Access Compliance Report

Public Rights-of-Way

Intersection ID: 12305	Main Street: E_5TH_ST	Cross Street: N_COLLEGE_ST	Location: W
ADA ID: E4506F99723A	Ramp Type: PerpDiag	Initial Pass/Fail: Fail	Overall Compliance: No
			Severity Score: 26.25

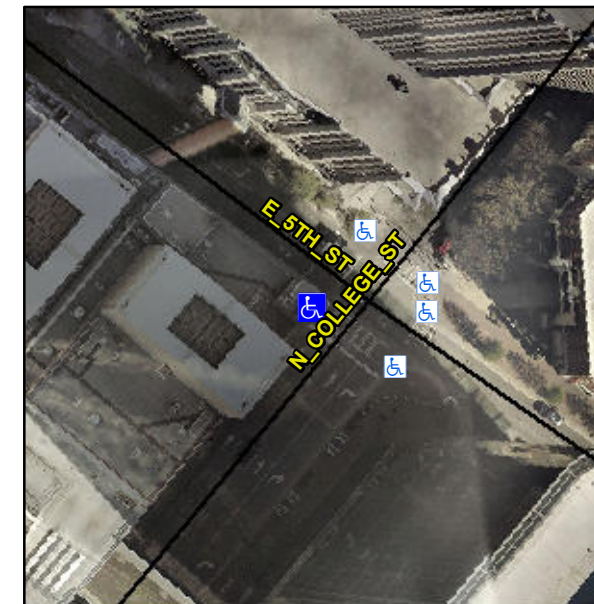
Not Found, R304.2.2, R304.5.3

Compliance	Description	Data	Compliance	Description	Data
N/A	Ramp Length (in)	87.0	No	Ramp Slope (%)	13.1
Yes	Ramp Width (in)	48.0	No	Ramp XSlope (%)	3.8
N/A	Flare Type LT	N/A	N/A	Flare Type RT	N/A
N/A	Flare Slope LT (%)	N/A	N/A	Flare Slope RT (%)	N/A
N/A	Flare Traversable LT?	N/A	N/A	Flare Traversable RT?	N/A
N/A	Landing Length (in)	N/A	N/A	DWS Provided?	N/A
N/A	Landing Width (in)	N/A	N/A	DWS Contrast?	N/A
N/A	Landing Slope (%)	N/A	N/A	DWS Length (in)	N/A
N/A	Landing X Slope (%)	N/A	N/A	DWS Full Width?	N/A
N/A	Landing Curb? (Y/N)	N/A	N/A	DWS Offset (in)	N/A
N/A	Shared Landing?	N/A			
N/A	Gutter Ponding?	N/A	N/A	Gutter Slope (%)	N/A
N/A	Gutter Lip Ht (in)	N/A	N/A	Gutter X Slope (%)	N/A
N/A	Painted X Walk1?	Yes	N/A	Painted X Walk2?	Yes
	X Walk 1 Direction	To S		X Walk 2 Direction	To N
N/A	X Walk 1 Width (in)	106.0	N/A	X Walk 2 Width (in)	117.0
	X Walk 1 Slope (%)	1.3		X Walk 2 Slope (%)	4.9
	X Walk 1 X Slope (%)	1.7		X Walk 2 X Slope (%)	3.7

Remove & Replace Curb Ramp With Two New Directional Ramps or Equivalent.
